Wollongong Local Planning Panel Assessment Report | 7 June 2022

WLPP No.	Item 3 - Addendum report to WLPP Item 2 – 26 October 2021
DA No.	DA-2021/136
Proposal	Residential - construction of a dwelling house and pools and Subdivision - Torrens title – two (2) lots
Property	1A Norman Street, Mangerton
Applicant	Ted Switaj
Responsible Team	Development Assessment and Certification - City Centre Major Development Team (NL)
Prior WLPP meeting	26 October 2021

ADDENDUM REPORT

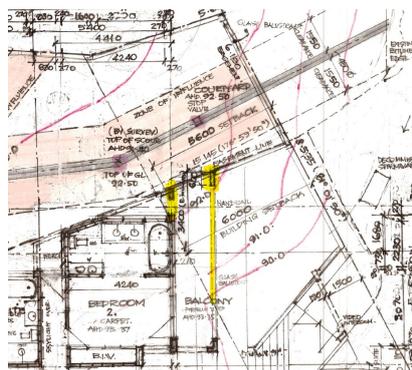
Concern	Comment
Impacts associated with pergola structure located within the 6m setback to Norman Street including views and encroachment over Sydney Water easement.	The pergola structure as notified is illustrated below

This has since been amended to the following:

The dwelling footprint no longer encroaches and the pergola and retaining wall structure within the front setback within the easement has also been removed.

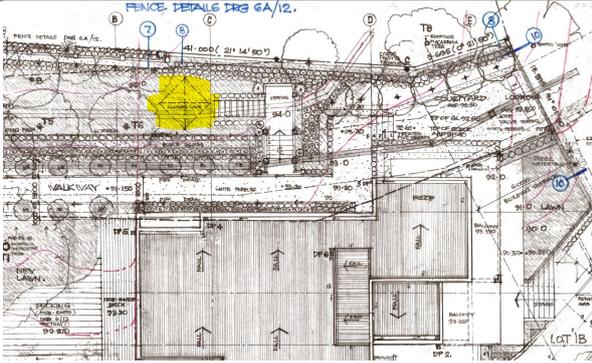
Concern	Comment
<p>Photo rendering #1: The first artistic rendering is very unclear as to its location on the site. If on the southern boundary it is not consistent with the fence design described in the 'Section and Fence Detail' plan (see Section of Fence 8) and as detailed in the Landscape plan. Nor is it compliant with the proposed DA conditions which required open style palisade style fencing.</p> <p>Photo rendering #2: The second rendering shows open fencing on the western boundary at the southern end. We have no objection to this rendering, however the spacing of vertical fencing elements has not been specified in the Section and Fence Detail plan (see Section of Fence 7).</p>	<p>The artist impression #1 is an oblique view from above of the southern boundary fence (see below)</p> 
<p>From an aesthetic and architectural standpoint, the open palisade fencing design (as specified in the earlier draft DA conditions) along the entire length of the western boundary should be required. This can be clearly seen by looking at the second Photo Montage and any privacy issue dealt with by suitable plantings and has previously been proposed by Council.</p>	<p>Open palisade type fencing was of primary concern on the western boundary adjoining the public pathway.</p> <p>The render looking west towards 1 Norman Street identifies open style palisade fencing as recommended by Council.</p>

<p>It is noted the open palisade type fencing does not extend for the full extent of the western boundary as illustrated below.</p>  <p>This is contrary to Council recommendations and condition 16(g) of the draft consent includes the extension of open palisade style fence treatment for the full length of the western boundary. This requirement is to remain.</p>

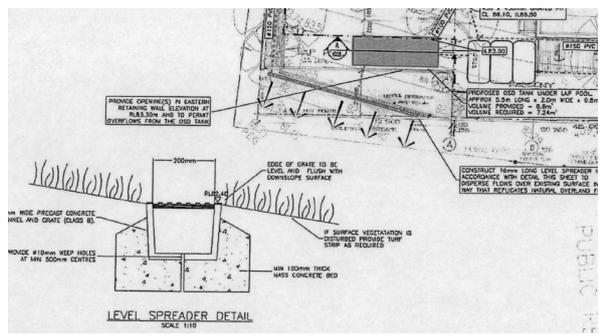
<p>Inadequacy of stormwater report and Council officer assessment of same.</p>	<p>The Stormwater report and concept plan have been prepared by a suitably qualified civil engineer and have been reviewed by Council's Stormwater Officer with respect to compliance with Council controls for stormwater management.</p>
<p>Potential impacts to trees adjacent the level spreader.</p>	<p>It is noted a level spreader was approved under the prior development application for the other dwelling on the site (DA-2017/1719) as illustrated below.</p>

The level spreader will be utilised by the new dwelling and the stormwater analysis has demonstrated that this is fit for purpose.

DRAWING NO. 1755-C01
ISSUE. 4
SHEET 1 OF 3

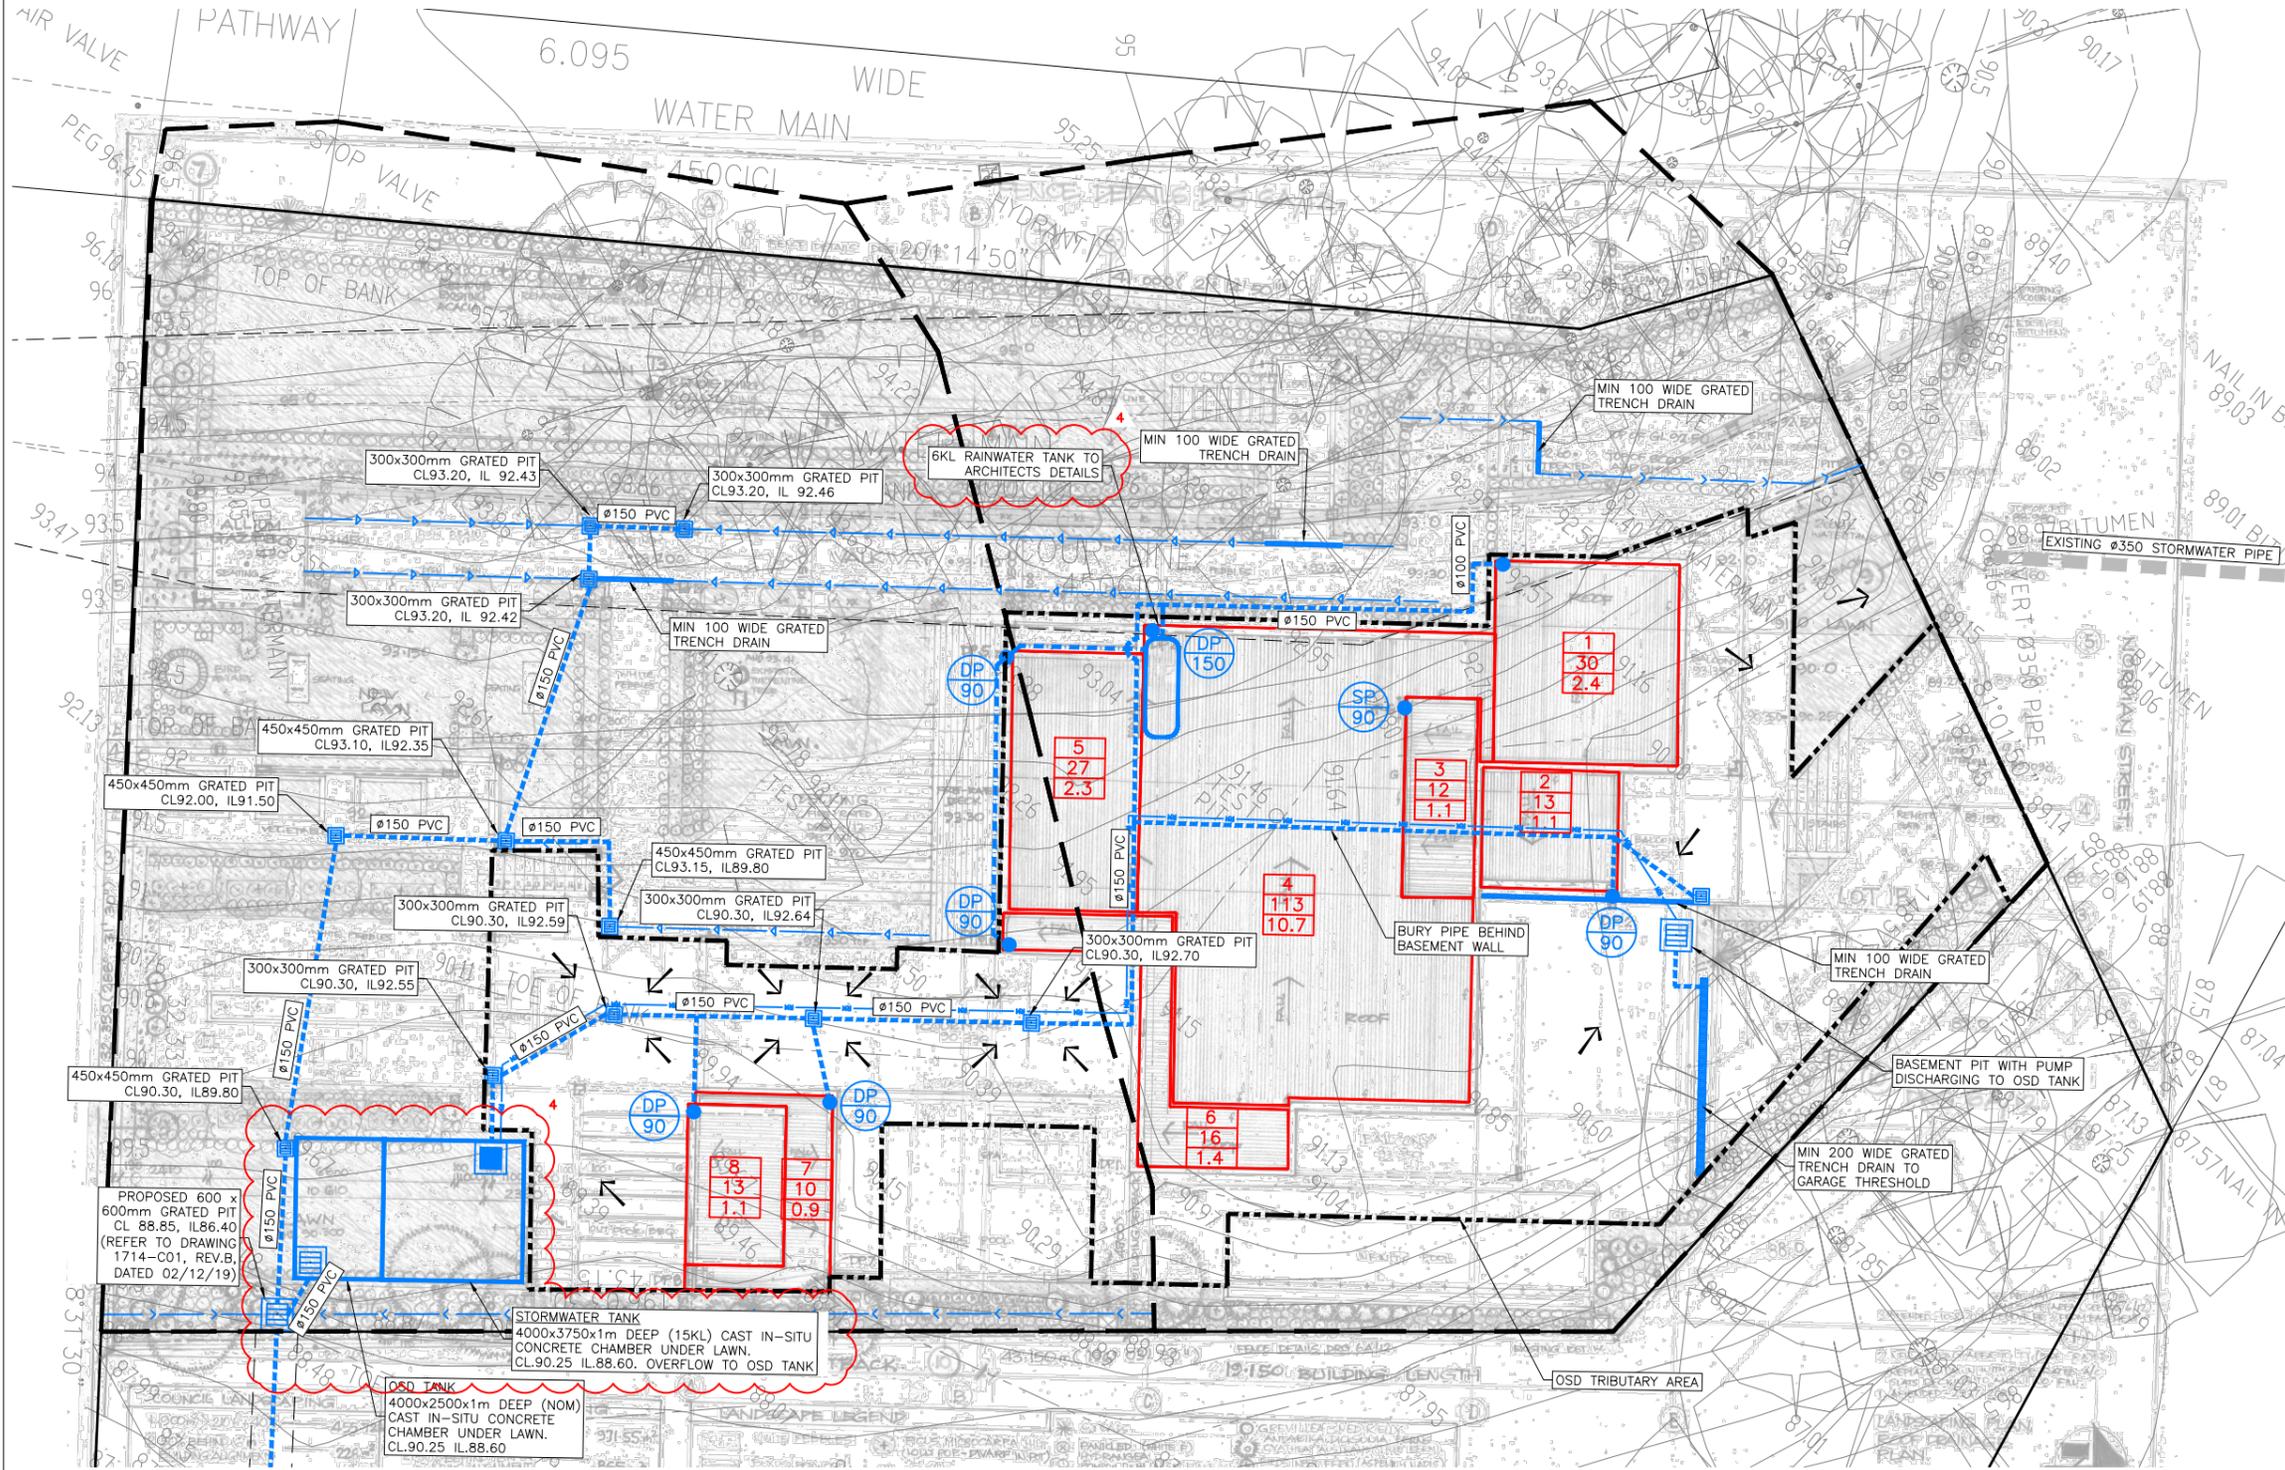
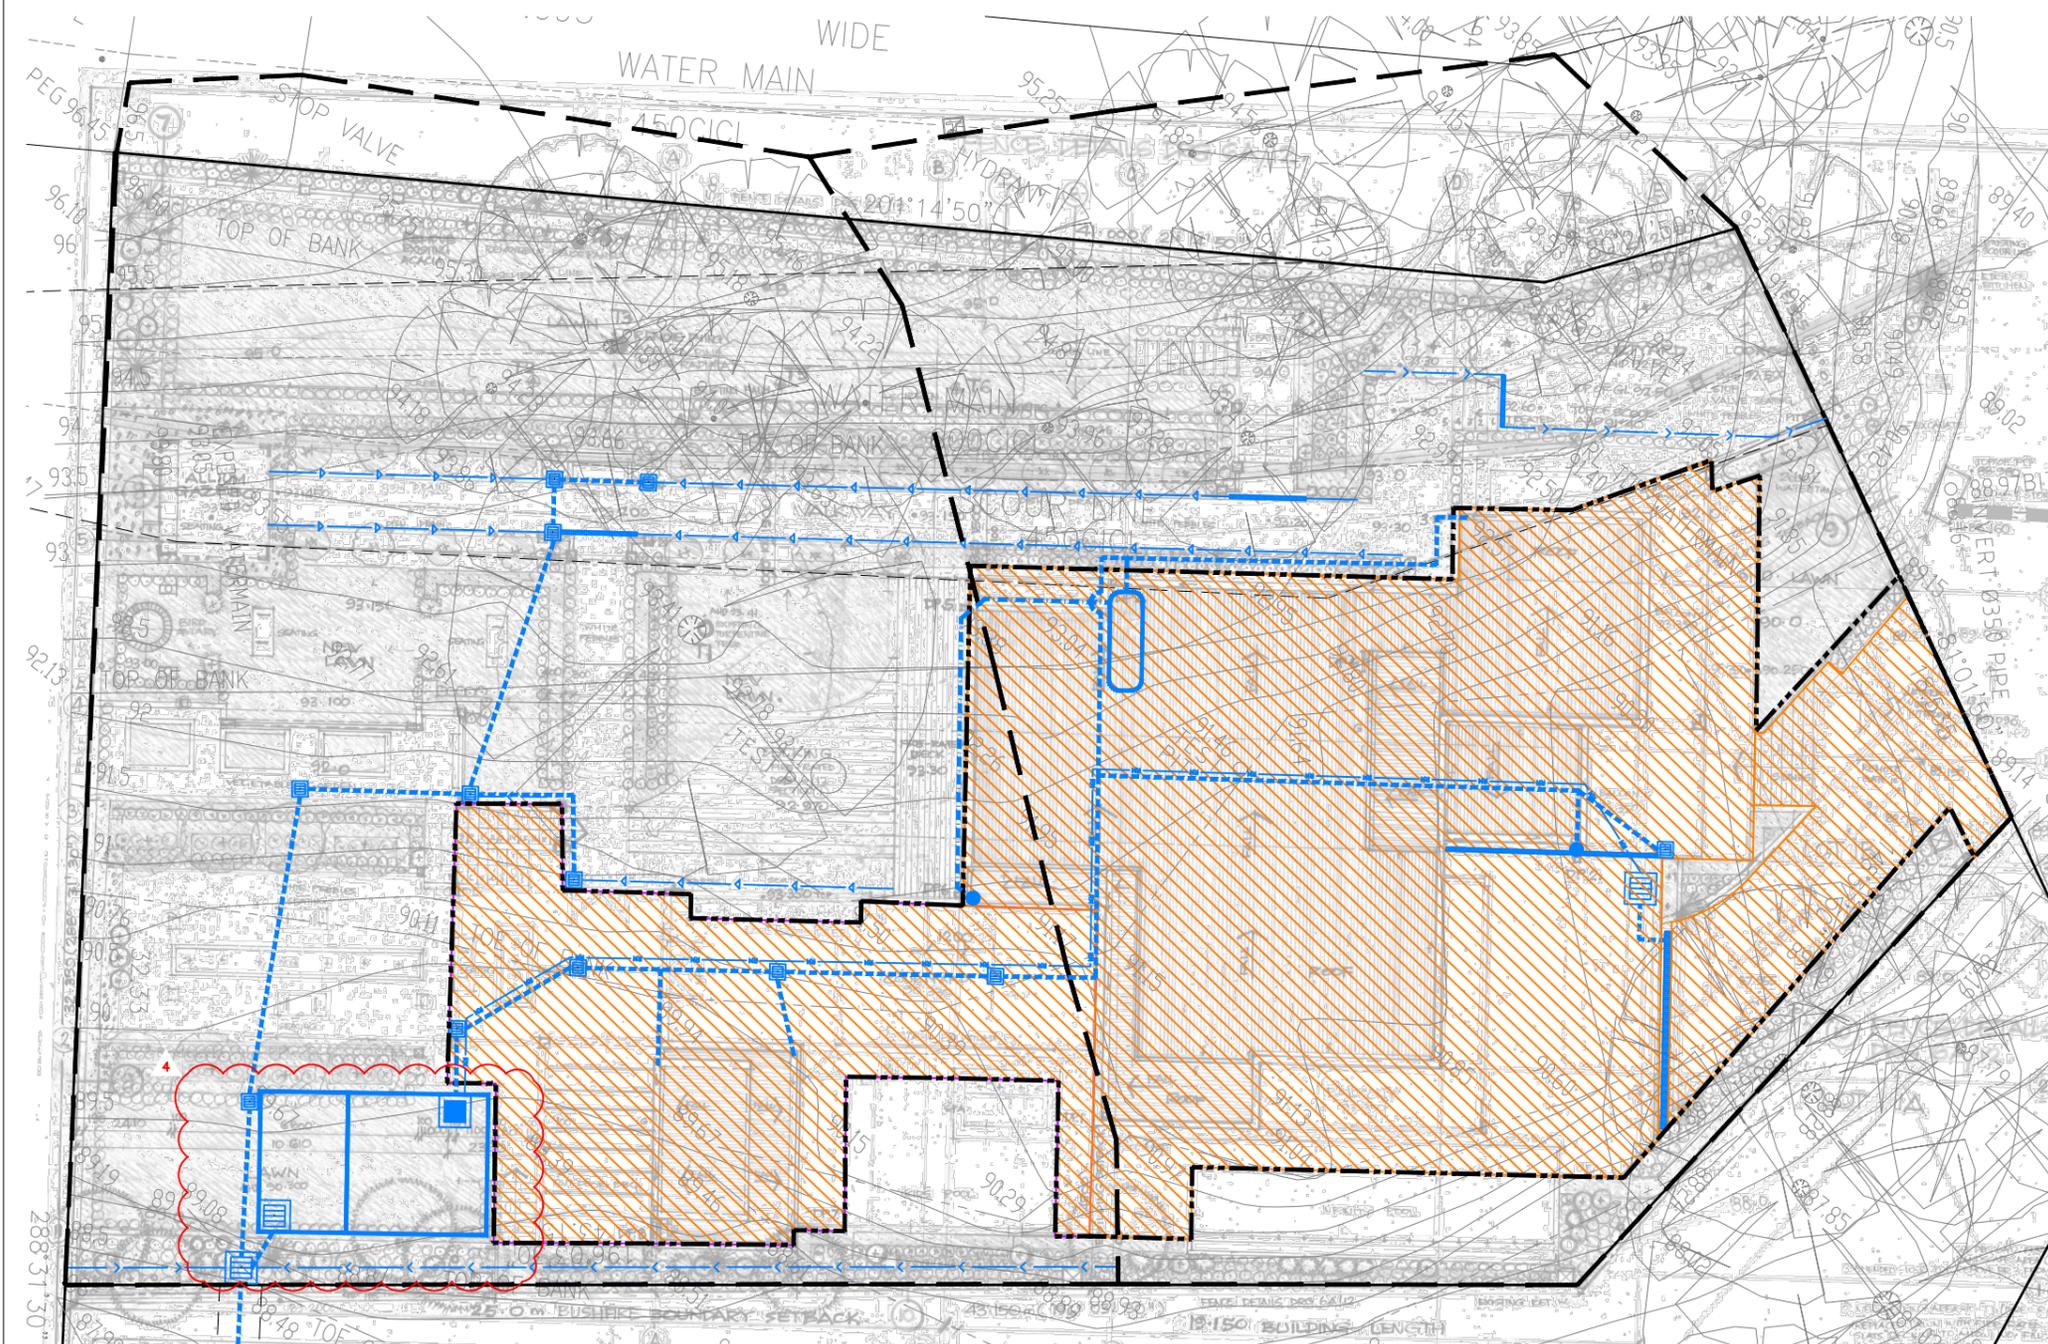
Further review of the proposed stormwater design reveals that the proposal is likely to result in an increase in volume of stormwater runoff affecting downslope properties. This has not been adequately addressed by the applicant.

The proponent has submitted Stormwater Management Report (Project No. 1755 dated 15 November 2021 prepared by Footprint Sustainable Engineering) and a revised Stormwater Concept Plan (1755-C01-4 dated 15 November 2021) indicating post development discharge of stormwater to the adjoining Council reserve to be 25% less than predevelopment flows (see **Attachment 6**). This has been reviewed by Council's Stormwater Officer who is satisfied the design meets Council requirements subject to appropriate conditions of consent which are contained at **Attachment 7**.

NOTE: OSD TANK SIZE PROPOSED HAS BEEN INCREASED TO 10m³ TO ASSIST IN OFFSETTING ADDITIONAL FLOWS BEING DIVERTED TOWARDS THE PROPOSED LEVEL SPREADER ON LOT 1A. REFER TO SHEET C03 FOR HYDRAULIC CALCULATION SUMMARY.
